Re: AWO Comments on the
Proposed 15-Day Modifications to
the Proposed Regulation Order

On behalf of The American Waterways Operators (AWO), thank you for the opportunity to provide comments on the California Air Resources Board (CARB) proposed amendments to the Commercial Harbor Craft (CHC) regulation.

Figure 2: Example of SCR Located in the Stack

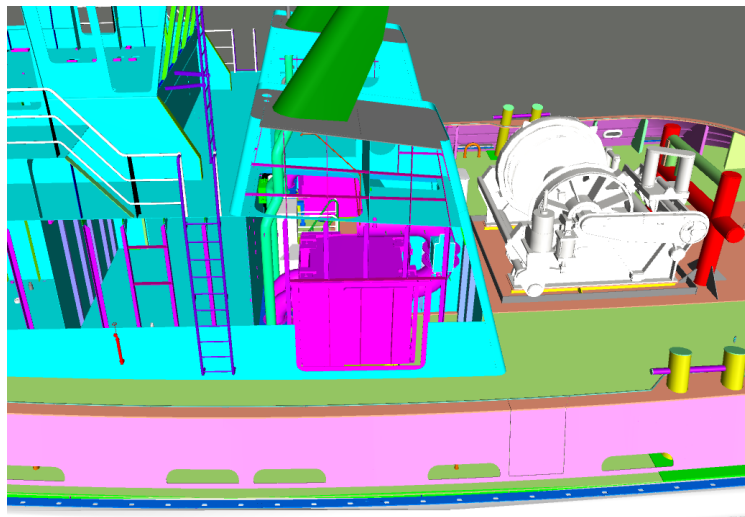
As described above, the engine room of a ship assist and escort tug may not allow for the installation of SCRs in the overhead. In these cases, the SCRs may need to be located in the stacks which requires more extensive structural modifications and typically has an impact on the engine room ventilation fan arrangement. This can also create challenges in accessing the SCR for routine maintenance. Figure 2 shows an example of an SCR located in the stack. Note that this was excerpted from a new design.
